MODEL 124.026 /030 as of 18.3.91 up to 18.3.91,  
 124.036,  
 124.05 as of 18.3.91 up to 18.3.91,  
 124.09,  
 124.128 as of 18.3.91 up to 18.3.91,  
 124.133 /19 /23 /29

## Revisions

21.4.95	Remedy and table in parts ordering note modified		
---------	--------------------------------------------------	--	--

P41.10-0036-01

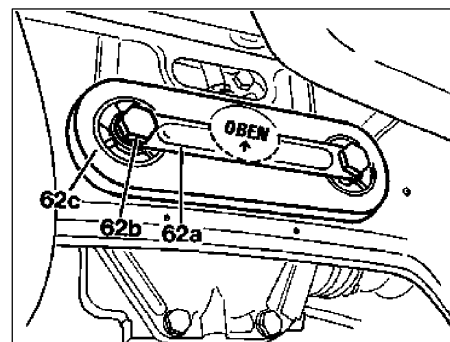
Damage code	Cause	Remedy	
41 001 20	Vibration in drive train.	1 Balance propeller shaft in vehicle.  ↓ If complaint is still present:  ↓	ra41001070080x
		2 Screw vibration damper (62c) on rear mount for rear axle center assembly, see table for tightening torque.

Number	Designation		Model 124
BA35.31-P-1004-02A	Retaining screw for fastening vibration damper and rear axle housing to rear axle carrier	Nm	150

Part no.	Designation	Quantity
124 350 06 75	Vibration damper	1
